ECN/PCN No.: 4262

Product Description: Ceramic SMD Crystal	Abracon Part Number / Part Series: ABM3	<input type="checkbox"/> Documentation only <input checked="" type="checkbox"/> ECN <input type="checkbox"/> EOL	<input checked="" type="checkbox"/> Series <input type="checkbox"/> Part Number
Affected Revision: V	New Revision: W	Application: <input type="checkbox"/> Safety <input checked="" type="checkbox"/> Non-Safety

Ceramic SMD Crystal

ABM3

Mechanical Dimensions:

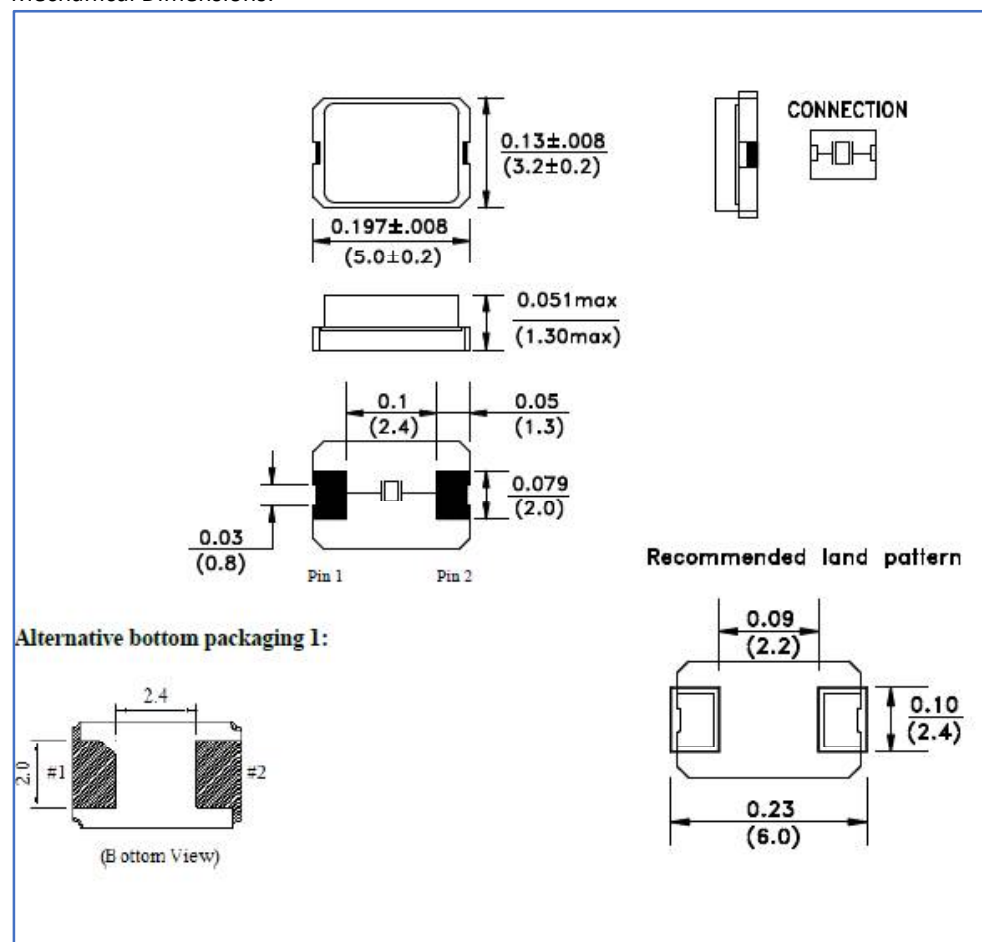
Prior to Change:

Mechanical Dimensions:

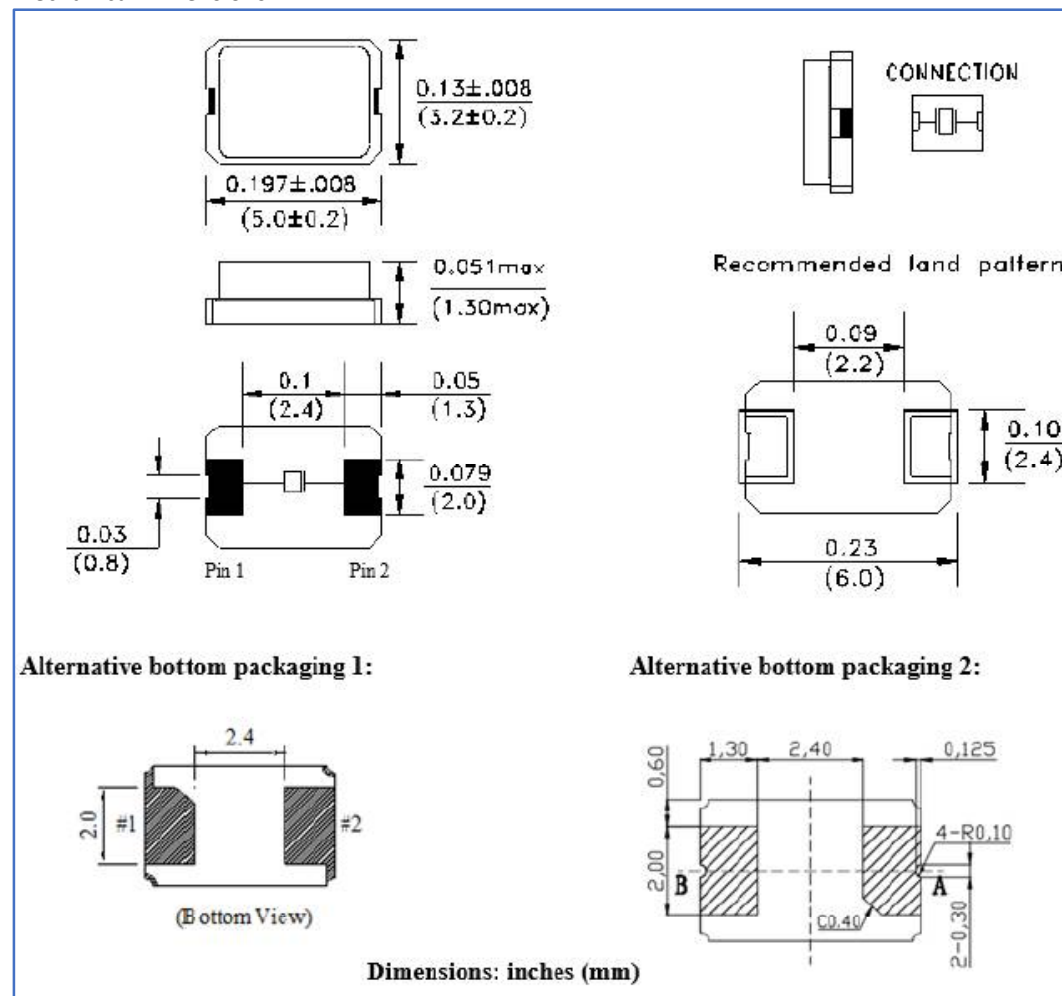
After Change:

Abracón introduced additional manufacturing sources to ensure product availability and to be in a better position to meet long term customer demand. Added an alternative bottom packaging structure to reflect the product produced by all manufacturing sources.

Change Declaration:
The added bottom packaging structure does not impact the electrical performance of the device.
